Rebuttal Report: Part 2, Review of SNWA Groundwater Model and Comparison with the Myers Spring/Snake Valley Groundwater Model				
Presented to the Office of the Nevada State Engineer				
On behalf of Great Basin Water Network and the Confederated Tribes of the Goshute Reservation				
August, 2011				
Prepared by:				
1 homes of Myen				
Thomas Myers, Ph.D.				
Hydrologic Consultant				
Reno, NV				
August 25, 2011				
Date

Figure 1: Snapshot from Figure 6-9 (SNWA, 2009) showing unweighted residuals.

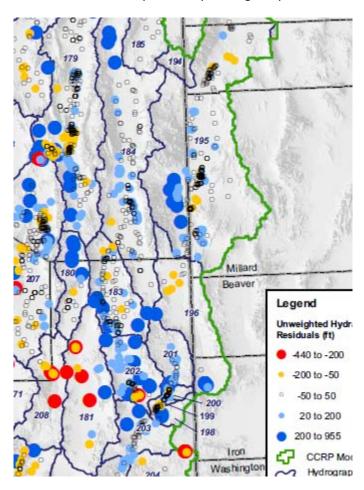
SNWA presented unweighted residuals, in Figure 6-9 (SNWA, 2009). This figure shows extreme bias in distribution of residuals. In the area of Dry Lake and Pahroc Valleys, six residuals are between - 440 and -220; five more are between -200 and -50 (Figure 1). Just east of Dry Lake Valley, in a trend that looks very much like the PRISM precipitation overestimates in Patterson, Lake, and Cave Valleys are at least ten residuals from 200 to 955 and another ten from 20 to 200 (Figure 1). The CCRP model ranges

from gross overestimation of head in Dry Lake/Pahroc Valleys (simulated exceeds observed in a negative residual) to gross underestimate of heads 10 to 20 miles to the east.

Two other obvious problems are the high positive residuals in north Spring Valley and along the mountain front in Snake Valley (Figure 1). This indicates the model does not accurately simulate the water table in the higher elevations along the boundary of the valleys. Such a poor connection would limit the simulated drawdown in these areas, potentially biasing the predicted results.

Figure 2: Snapshot of hydrogeology and calibrated K, model row 359. This section crosses Pahranagat and Coyote Spring Valley. (file xs_rum_rows-rev2-7o-map-hd-kh-s-1lay-ucth814-1-4748.pdf)

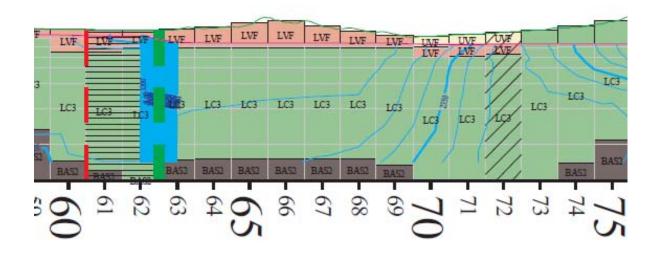
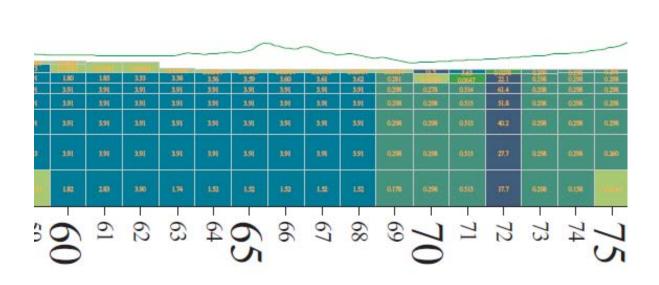
The Pahranagat shear zone causes a head drop of about 700 feet across one model cell, as represented by the blue in the hydrogeology at column 62 (Figure 2); this is modeled with a series of HFBs. Further east (right) in column 72 is a conductive fault in LC3 (lower carbonate rock). The conductivity (K) in the fault ranges from 17 to 62 ft/d, over 3281 feet, while the surrounding LC3 cells have K about 0.5 ft/d. The high K fault runs north/south through Coyote Spring Valley to just south of the Pahranagat Shear zone (Figure 3); the fault is shown on Figure 3 just east of the highway; it ends approximately where it intersects the shear zone. Based on K, this fault zone would transport vastly more groundwater than the surrounding rock.

Figure 4: Hydrogeology and K values for row 407. (file xs_rum_rows-rev2-7o-map-hd-kh-s-1lay-ucth814-1-4748.pdf)

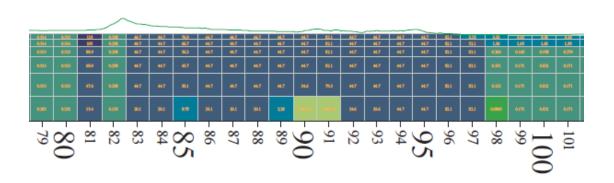
Further south three faults converge in Coyote Spring Valley which allows groundwater to move to the Muddy River Springs area through a zone of very high K LC3 rock. Figure 4 shows two of the faults and high K zones right of the faults; Figure 5 shows the convergence of these faults and the fault on the east which impedes the flow causing it to surface at the springs. Figure 6 shows the three faults north of the springs near their convergence into the broad high K LC3 material. These figures demonstrate how a model simplifies complex geology as mentioned by D'Agnese (2011, p. 10). The problem with this is the broad zones with very high K cover as much as 20 model rows by 15 columns, or about 300 square kilometers. There is no geologic evidence for such a broad fractured zone in this area. Such a zone may bias the results for this area. The springs probably discharge from a narrow highly conductive fracture zone which could be drained sooner by pumping than would a 300 square km, 10,000 feet thick zone, with high K.

Figure 7: Snapshot of portion of row 128 in center of Spring Valley showing hydrogeology (upper) and K (lower). (file xs_rum_rows-rev2-7o-map-hd-kh-s-1lay-ucth814-1-4748.pdf)

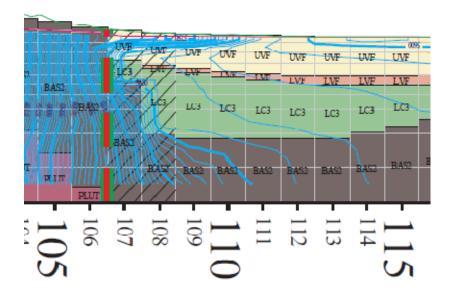
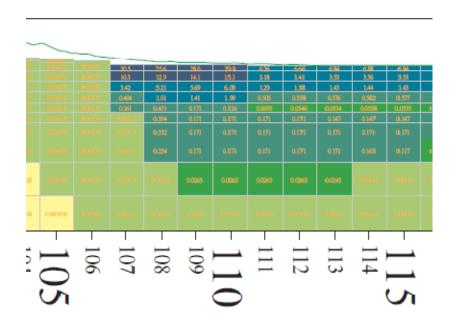
SNWA uses high K cells on the boundary in the uppermost layers (Figure 7). These presumably were set to allow recharge into the zone, perhaps in relation to the manual adjustment they made to their runoff pathways (SNWA, 2009, p. 5-14). Underlying the high K cells, the K is an order of magnitude lower, which causes the groundwater to pond, as shown in the contours on upper Figure 7.

Figure 8: Snapshot of row 160 showing hydrogeology from Steptoe Valley (left) to Spring Valley. (file xs_rum_rows-rev2-7o-map-hd-kh-s-1lay-ucth814-1-4748.pdf)

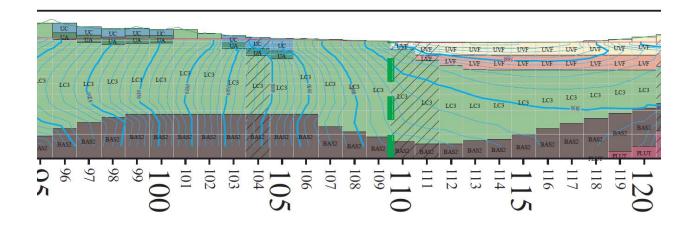
Groundwater contours along row 160 show a gradient through carbonate rock from Steptoe to Spring Valley (Figure 8). The model includes an HFB, but no mounding of contours. This is an example of how the SNWA model does not reflect the geology by Rowley et al (2011). Many more rows also show flow in this direction. However, the uppermost layers show a modest mounding of flow so that contour maps may suggest there is a divide. Figure 9 and 10 demonstrate how a groundwater level contour map can show a divide while there is clearly flow at depth.

Figure 11: Snapshot of row 202 showing hydrogeology (top) and K values near Shingle Pass. (file xs_rum_rows-rev2-7o-map-hd-kh-s-1lay-ucth814-1-4748.pdf)

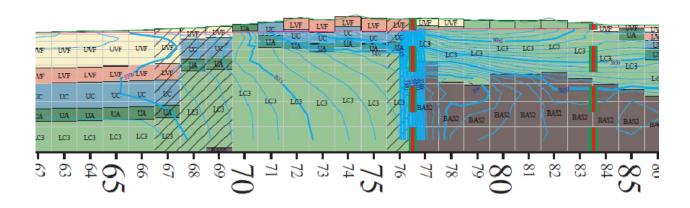
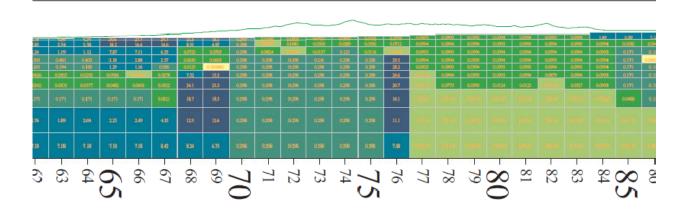
The model conceptualization of Shingle Pass is as complicated as any in the model, with several formations including carbonate rock and several faults (Figure 11). The faults within Cave Valley are simulated with HFBs which prevent flow from leaving Cave Valley. The mountain front faults on the east side of White River Valley have very high K, being high displacement faults. The high K zones extending north and south along the west side of the Egan Range capture substantial recharge from the mountains and deliver it to the spring areas. However, these faults do not have an HFB which would force water to surface in to the springs. Thus, SNWA biases the model to prevent Cave Valley flow from supporting the springs in two ways – HFBs within Cave Valley preventing flow to White River Valley and high K faults along the east side of WRV that brings water from the north to the springs along with no barrier to cause the water to surface at these points.
